*Acoustic Environmental & Impact  
Assessment Report  
and  
Aircraft Noise Impact Assessment*

**For proposed Vikings Club**

**No. 37 Tomsitt Dr, Jerrabomberra**

**Reference No.: 2023-258 Rev. 2 -**

Figure 12 - Sound Barrier Locations – Ground Floor

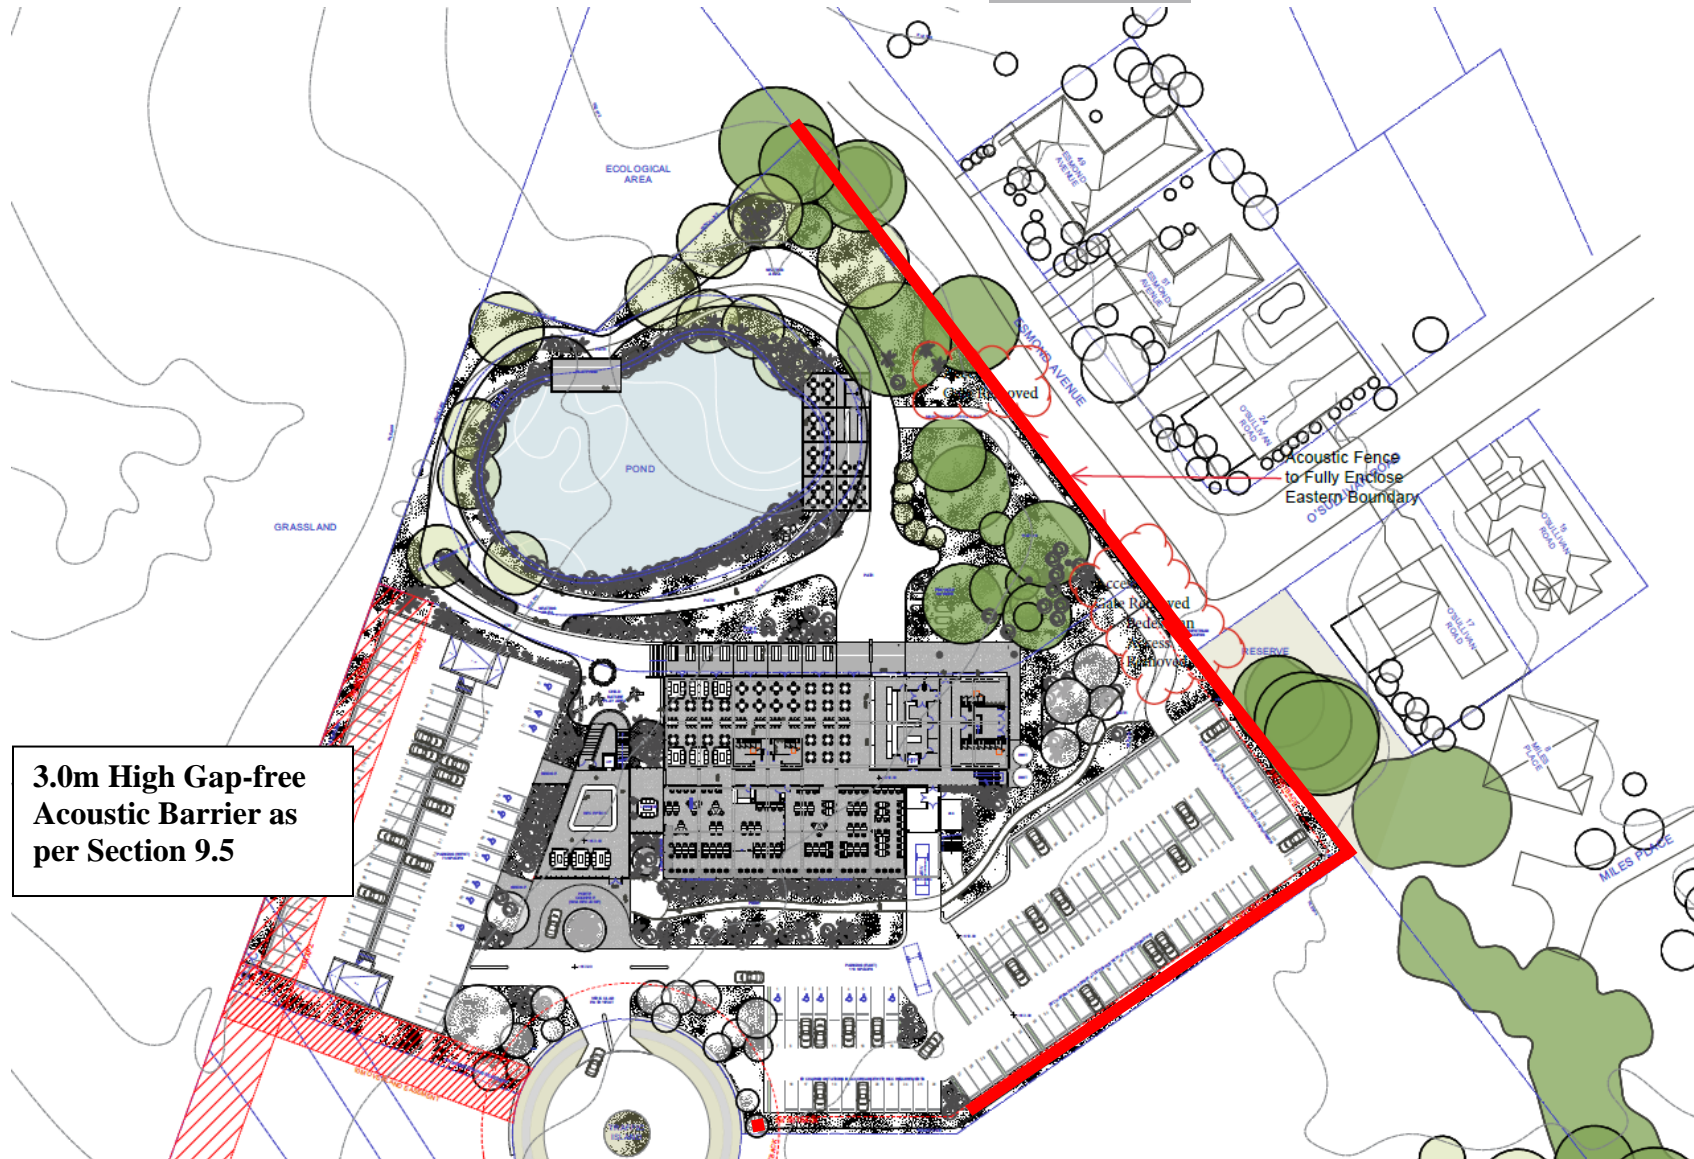
A 3.0m high gap-free acoustic barrier is to be installed along the eastern boundary of the site and around the perimeter of the eastern parking lot as per Figure 12 – Sound Barrier Locations – Ground Floor. Acoustic barrier form of construction is any of the following:
